**IEEE P802.3an (10GBASE-T)
Task Force
Closing Plenary Meeting Report**

**Vancouver, BC
November 17, 2005**

Draft Change #1

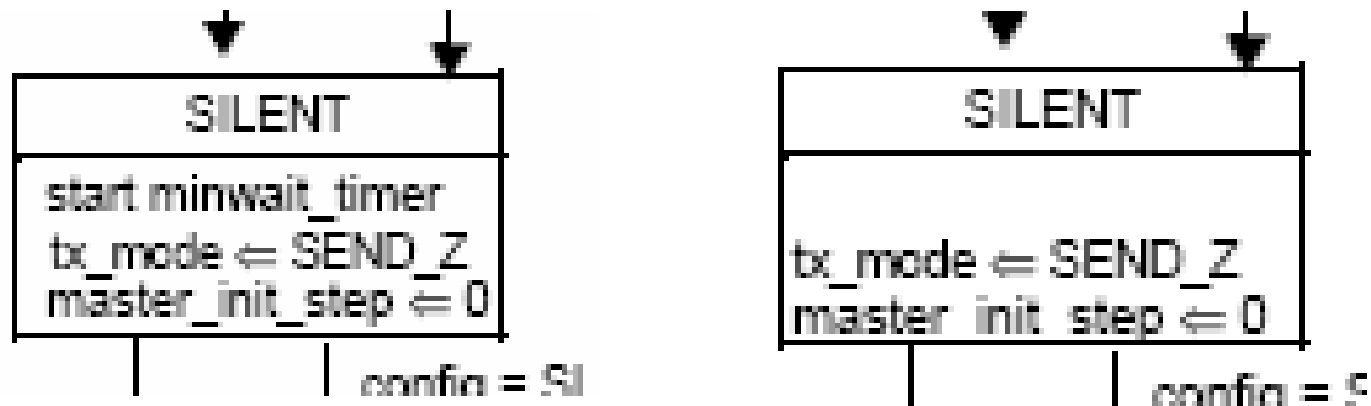
:
Class F	:
new Class E _{<u>E_A</u>} / Augmented Category 6	:

- Change made in 4 places where “new Class E” was replaced with “Class E_A”
